SUBJECT: ISSUANCE OF AMENDMENT NO. 16 TO FACILITY OPERATING LICENSE
NPF-21, WPPSS NUCLEAR PROJECT NO. 2

License No. NPF-21
Amendment No. 16

ATTACHMENT TO LICENSE AMENDMENT NO. 16
FACILITY OPERATING LICENSE NO. NPF-21
DOCKET NO. 50-397

AMENDMENT NO. 16 TO NPF-21

FIGURE 3.3.10-1

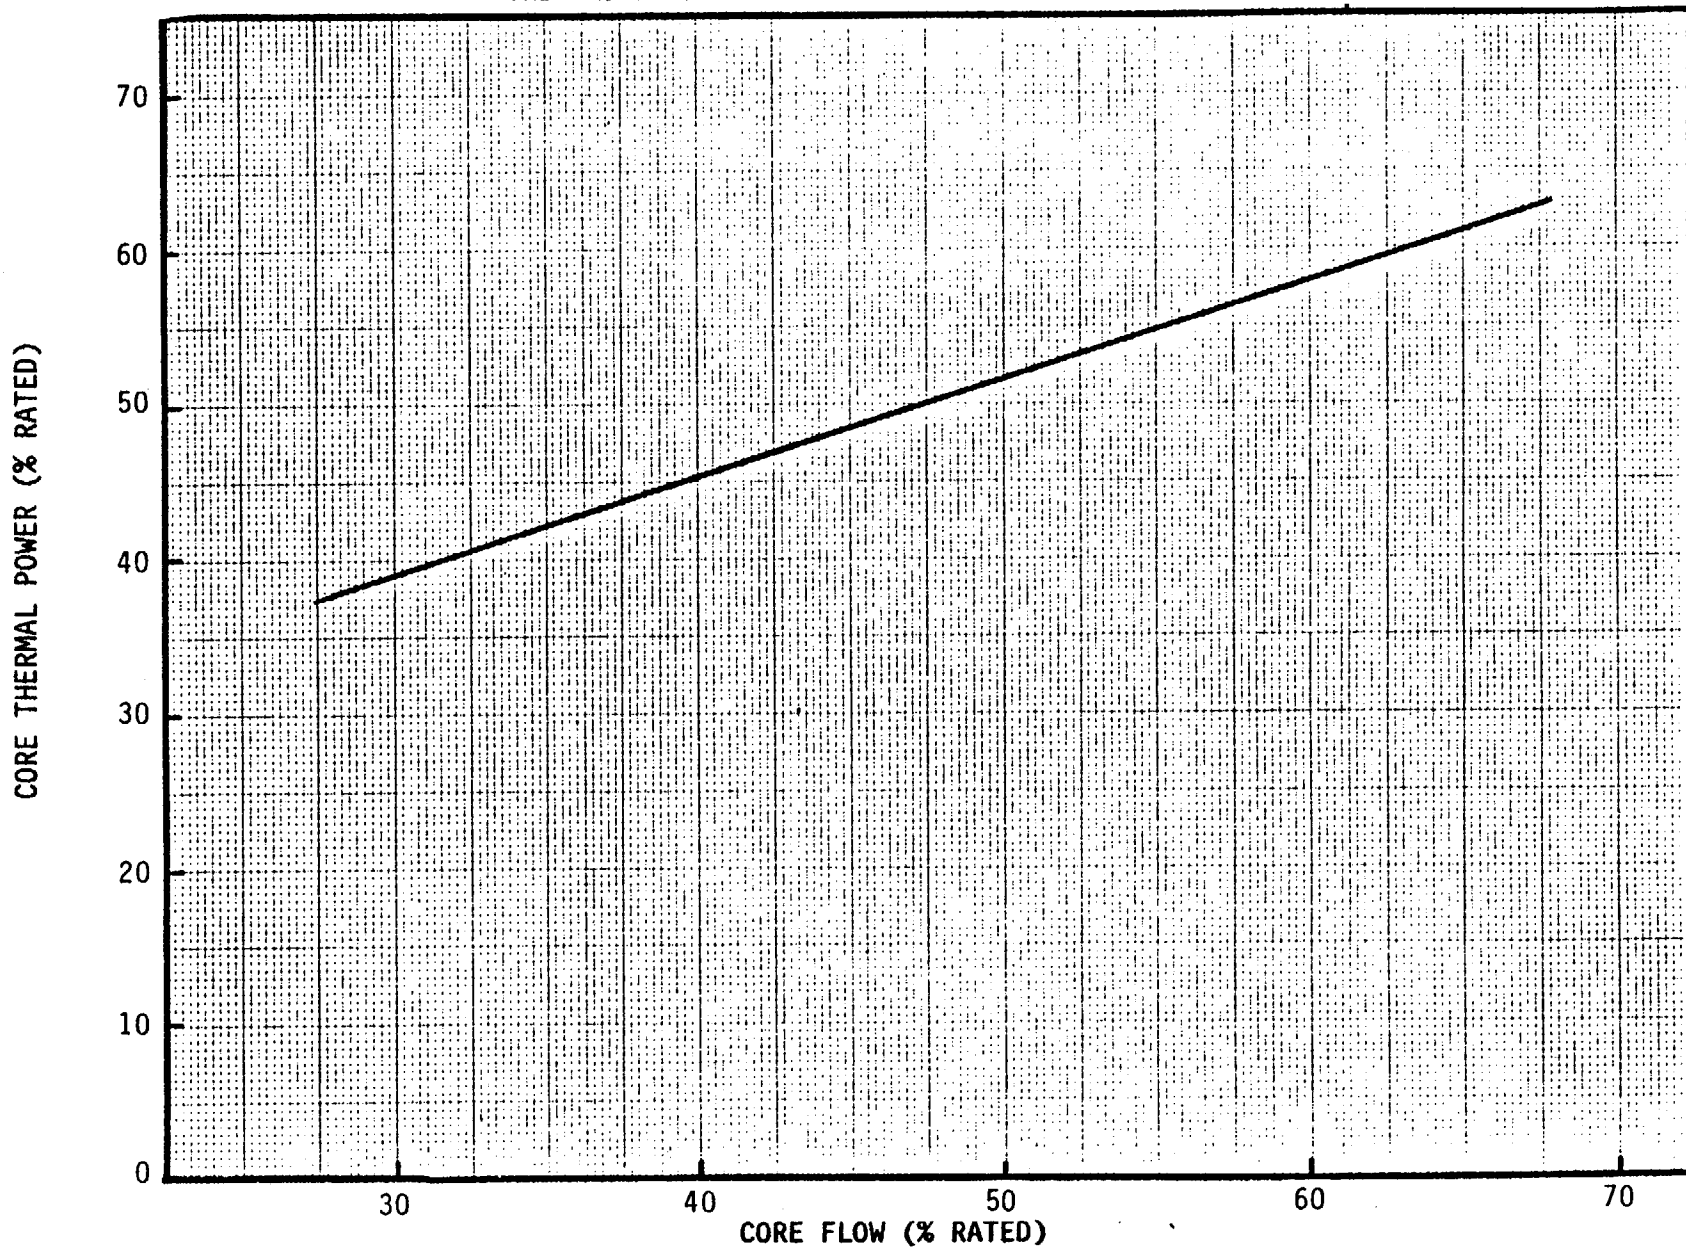
3.3.10 The APRM and LPRM* neutron flux noise levels shall not exceed three (3) times their established baseline value.

APPLICABILITY: OPERATIONAL CONDITION 1 with two reactor coolant system recirculation loops in operation with THERMAL POWER greater than the limit specified in Figure 3.3.10-1 and total core flow less than 45% of rated total core flow or with one reactor coolant system recirculation loop not in operation with THERMAL POWER greater than the limit specified in Figure 3.3.10-1.

With the APRM or LPRM* neutron flux noise level greater than three (3) times their established baseline noise levels, initiate corrective action within 15 minutes to restore the noise levels to within the required limits within 2 hours or reduce THERMAL POWER to less than or equal to the limit specified in Figure 3.3.10-1 within the next 2 hours.

4.3.10.3 With one reactor coolant system recirculation loop not in operation, establish a baseline APRM and LPRM* neutron flux noise level value with THERMAL POWER less than or equal to the limit specified in Figure 3.3.10-1 prior to entering the APPLICABLE OPERATIONAL CONDITION of Specification 3.3.10 provided baselining has not been performed with one reactor coolant system recirculation loop not in operation since the most recent CORE ALTERATION.#

FIGURE 3.4.1.1-1

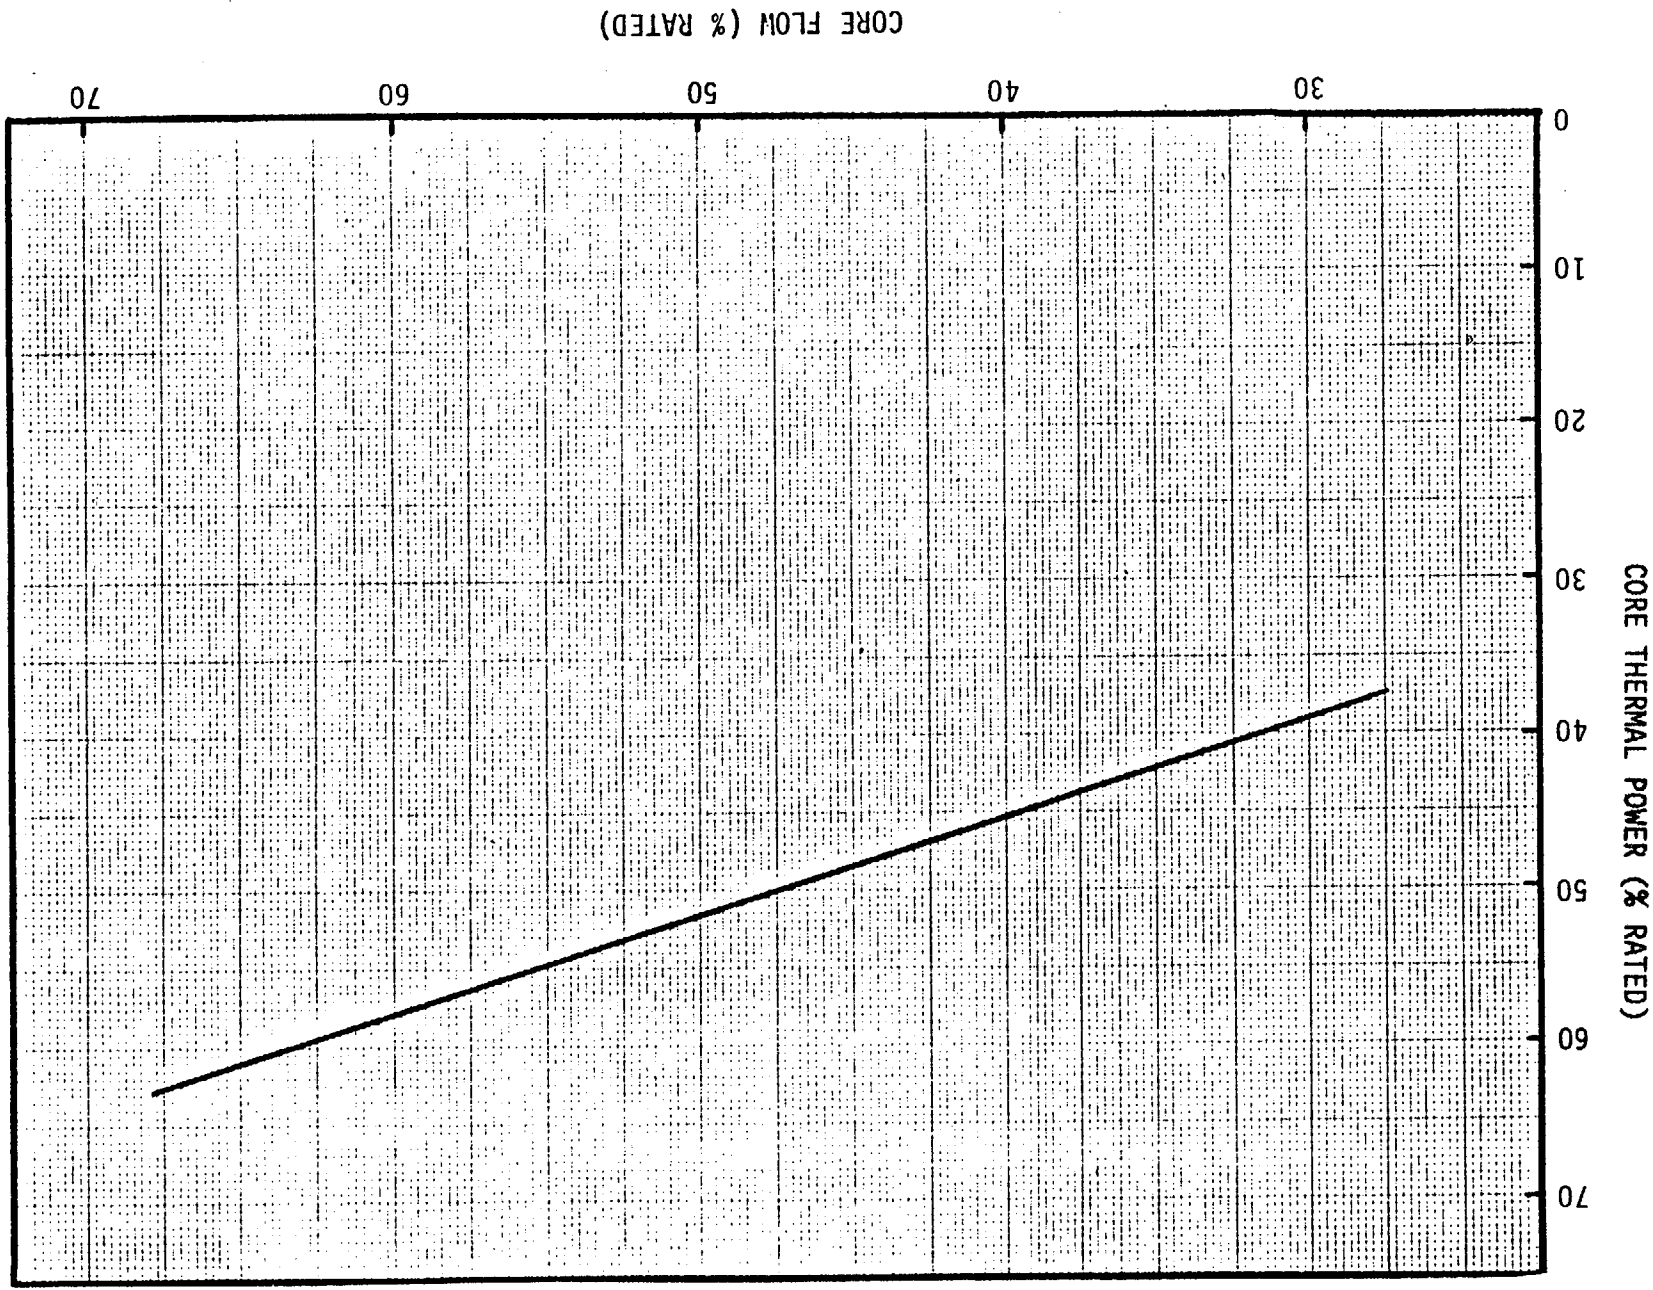
- b) The THERMAL POWER shall be less than or equal to the limit specified in Figure 3.4.1.1-1 or the provisions of Specification 4.3.10.3 are satisfied. With one reactor coolant system recirculation loop not in operation and with THERMAL POWER greater than the limit specified in Figure 3.4.1.1-1, and the provisions of Specification 4.3.10.3 having not been satisfied, initiate action within 15 minutes to reduce THERMAL POWER to less than or equal to the limit specified in Figure 3.4.1.1-1 within 4 hours. The provisions of Specification 4.3.10.3 must be satisfied prior to resuming power operation above the limit specified in Figure 3.4.1.1-1.

- i) With one reactor coolant system recirculation loop not in operation and THERMAL POWER greater than the limit specified in Figure 3.4.1.1-1 and core flow less than 39% of rated core flow, initiate action within 15 minutes to reduce THERMAL POWER to less than or equal to the limit specified in Fig. 3.4.1.1-1 or increase core flow to greater than or equal to 39% of rated core flow within 4 hours.

- c. The core plate ΔP noise is less than 200% of the established core plate ΔP noise patterns.
- d. Core flow is greater than or equal to 39% of rated core flow when core THERMAL POWER is greater than the limit specified in Figure 3.4.1.1-1.
